Rezoning Transportation Analysis

Petition Number: #2022-105

General Location Identifier: 05549113, 05549114, 05549115, 05549128

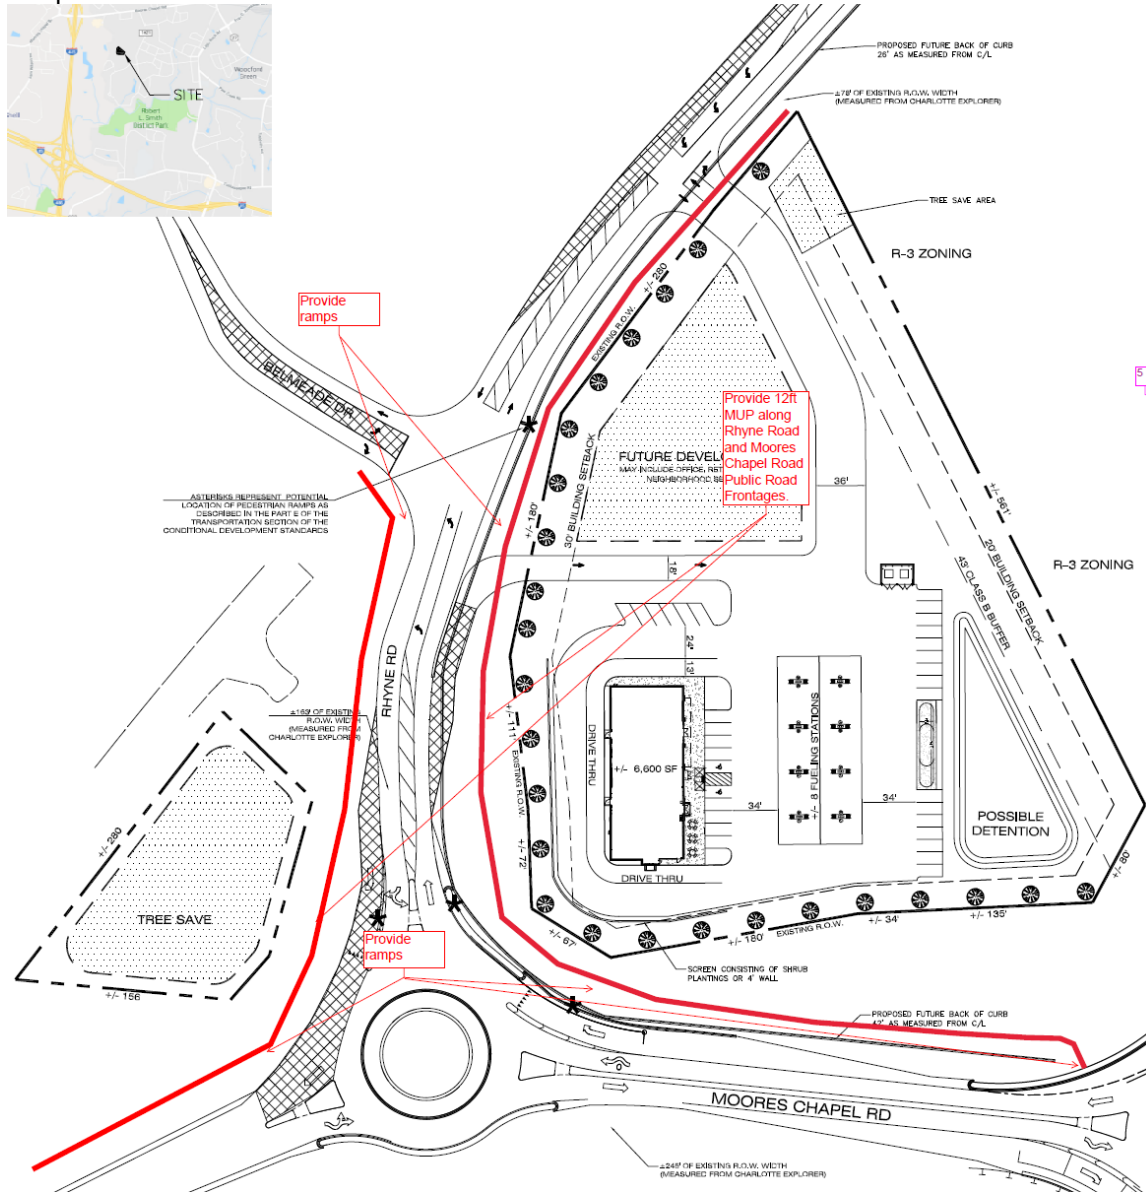
2. Revise site plan conditional note in the transportation section letter e. for Southbound I-485 Off Ramp to say, "Extend existing southbound right turn lane to provide 400' of storage and appropriate taper."

REWORD:
Extend SBR to provide 400' of storage and appropriate taper.
Existing SBR is 200'.

Clarifying Comment from 12/22/2022: Reword improvement at Southbound I-485 Off-Ramp to what is shown in the picture above.
